BEACHBUOY EXPERT REVIEW

Document title: Beachbuoy Review - Overarching Report

Document reference:5212087_010 Revision	Purpose description	Originated	Checked	Reviewed	Authorised	Date
5.0	Report following amendments made after review by & discussion with Southern Water	HG	HV and SA	VJ and NM	VJ	04/12/23
6.0	Updated report following discussion with Southern Water – new section 4.6 and update to sections 4.2 to 4.5.	HG	BC	VJ	VJ	29/01/24
7.0	Section 4.6 removed and minor edits following Southern Water review	HG	BC	VJ	VJ	09/02/2024

Figure 6.3. Schematic illustration of tidal pumping impact on sediment transport processes (also applicable to FIO processes).

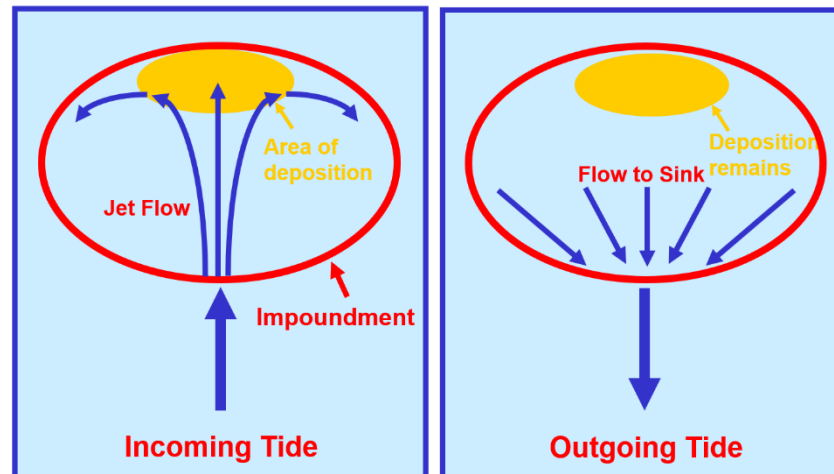
Review Question – General Modelling	Responses (as provided by the reviewer – details in Section 2)
7. Is there a problem with modelling discharge inputs into harbour/river/estuary confined bodies of water. E-Coli longevity, dispersion and advection is going to be different in confined water spaces as compared with the open sea. Is this more concentrated material from a confined body of water considered in the modelling from a limits perspective? (eg a discharge into Langstone Harbour will come back when the tide turns and affect a bathing water like Eastney in less than 12 hours when initially no impact)	*Water Quality* NB *E. coli* is irrelevant for any health risk evaluations in marine waters. This approach could be deployed to address such situations under different tidal conditions. I have no expert view on how this could be modelled but the MMO approved phage tracers have been deployed to inform the modelling process for UK water companies. However, very different microbial decay rates may be experienced in a turbid harbour environment within a stream-dominated estuarial system. It is understood that SWS will use a variable T_{90} in the updated model. *Oceanographic Modelling* This is an important point for consideration and particularly where the harbour entrance is narrow and near a bathing water, such as the case for Langstone Harbour. In modelling such a narrow-entranced basin it is critical to ensure that the flow and FIO flux across the entrance is predicted as accurately as possible. For this purpose, it is desirable to use an unstructured grid model, thereby enabling a very fine grid resolution to be set up in the entrance region to reproduce accurately the area of flow (including deep channels) and velocities through the basin entrance. This point is covered in Recommendations 1 and 4. In confined water bodies with a narrow entrance, such as harbours and large marinas, the treatment of many of the processes outlined in Section 2[2] become even more critical, particularly turbulence, dispersion and diffusion. However, it should also be noted that a conservative decay rate (or T_{90} value) was used in calculating the *E. coli* concentration values. Also, where a tide induced jet flows through a relatively narrow harbour entrance it can lead to the process of 'tidal pumping' (Zheng, et al., 2016) wherein effluent/sediment discharges at the head of the harbour can accumulate over time, leading to higher concentrations of bacteria than those discharging from the outfall, particularly at night. The process of tidal pumping is schematically illustrated in Figure 6.3 below. Although the paper by Zheng et al. (2016) focuses on nitrates, as mentioned in the paper similar processes can occur with bacteria. More recent studies by the writer and others have shown that bacteria adsorption and desorption onto the sediments (on the bed and in suspension) can lead to the decay rate for bacteria being very long, particularly for dark conditions. With sediment brought back into suspension on the subsequent spring tide, particularly under storm conditions, then sediment transport and bacteria desorption can also be a mechanism of FIO transport in a river or coastal basin. This was found to be the case in the River Ribble Basin

study and contributed to the flux of *E. coli* from the Ribble catchments to the Fylde Coast (Huang G., Falconer, Lin, & Xu, 2022). In the past the writer also has experience of studying a range of water quality parameters in Poole Harbour and Holes Bay, where several of the pro-cesses referenced above were found to be critical (e.g., Falconer, 1986).

Figure 6.4. Schematic illustration of eddies causing sediment to accumulate at centre: (a) uniformly distributed initially, and (b) accumulated at centre after stirring.

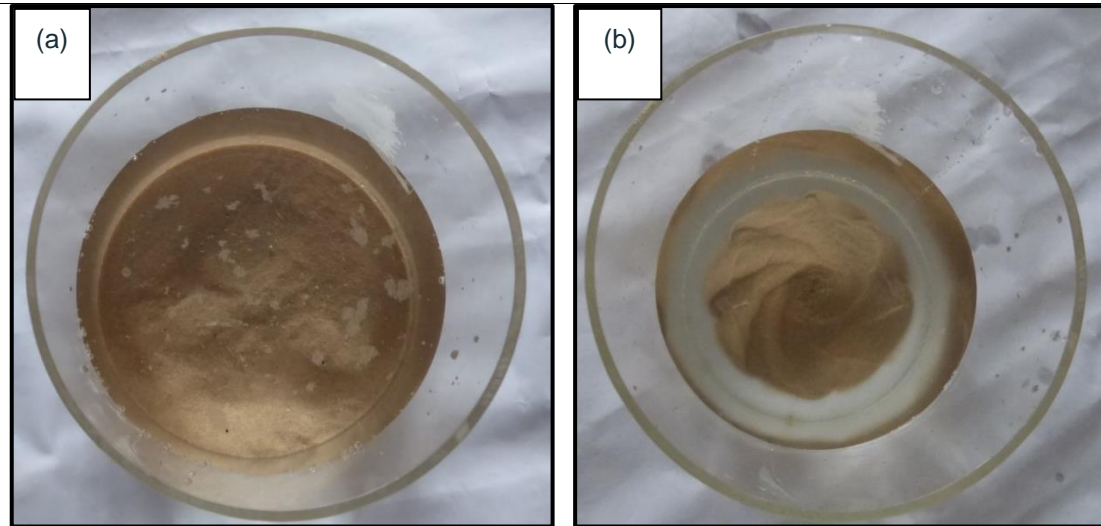
As outlined in response to questions 10 and 11 above the writer has reservations about the accuracy of the model predictions, particularly regarding the hydrodynamics, for the reasons outlined in Section 2 of this report[2]. For example, in the writer's experience a finer grid resolution and a more accurate turbulence model, at least based on the local velocity and depth, would have been expected to show signs of a pronounced and well-structured tidal eddy around the headland to the west of Pennington and in the narrow Solent entrance. However, in viewing the spring tide currents throughout the tide in this region, there is no evidence of the formation of any well-structured tidal eddies in the region, as illustrated in the model current predictions shown in Figure 3.7 (a-m), in the Southern Water Services report (1998). The prediction of tidal eddies in nearshore coastal waters can be critical in assessing bathing water quality (see Figures 1 and 2[2]), and particularly for shellfish water quality, as the formation of tidal eddies leads to sediment accumulation at the centre of the eddy and pollutant trapping – particularly near the bed – as illustrated for sediments in Figure 6.4.

Furthermore, for several of the current predictions in Figure 3.5 of the Southern Science report, where comparisons are reported against Admiralty Chart data, the comparisons show several predicted peak currents which are noticeably less than the Chart data, particularly as shown in Figure 3.5 (e) where the measured current is ca. 2.0 m/s, whereas the corresponding predicted value is ca. 1.0 m/s, i.e., only 50% of the Admiralty Chart value. This comparison is well out with the FWR criteria, which is widely used within the water industry and adopted with reasonable confidence, particularly in deeper water and as for this region. Further field data collected with ADCPs and a much finer grid resolution model are therefore recommended. These points are included in Recommendations 3 and 4.
